## **REMARKS**

### **AMENDMENTS TO THE DRAWINGS**

Fig-20

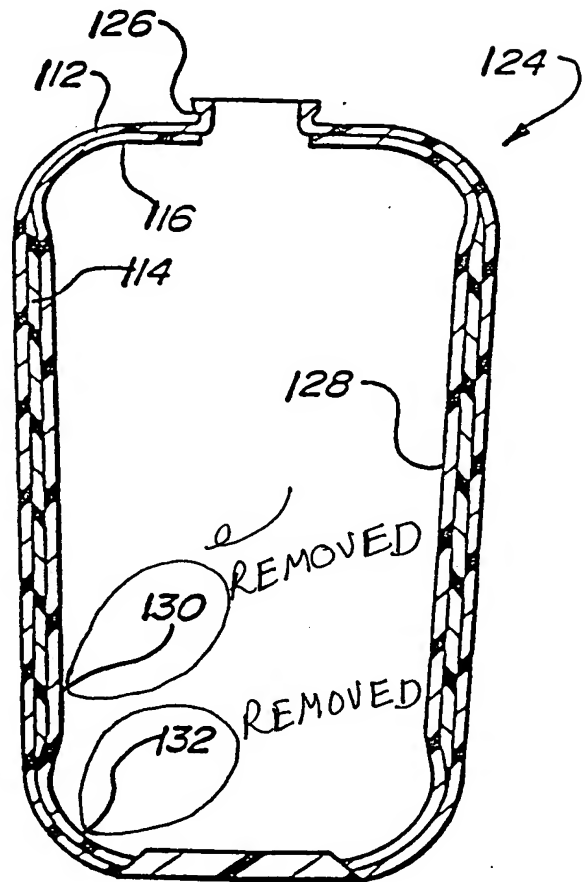
Reference signs 130 and 132 appear in Figure 20 but are not mentioned in the description. Reference sign 170 appears in Figure 21 but is not mentioned in the description. Applicants present replacement figures in which reference signs 130, 132, and 170 have been removed.

The attached sheets of drawings include changes to Figures 20 and 21. The attached sheets, which includes Figures 19-23, replace the original sheets including Figures 19-23.
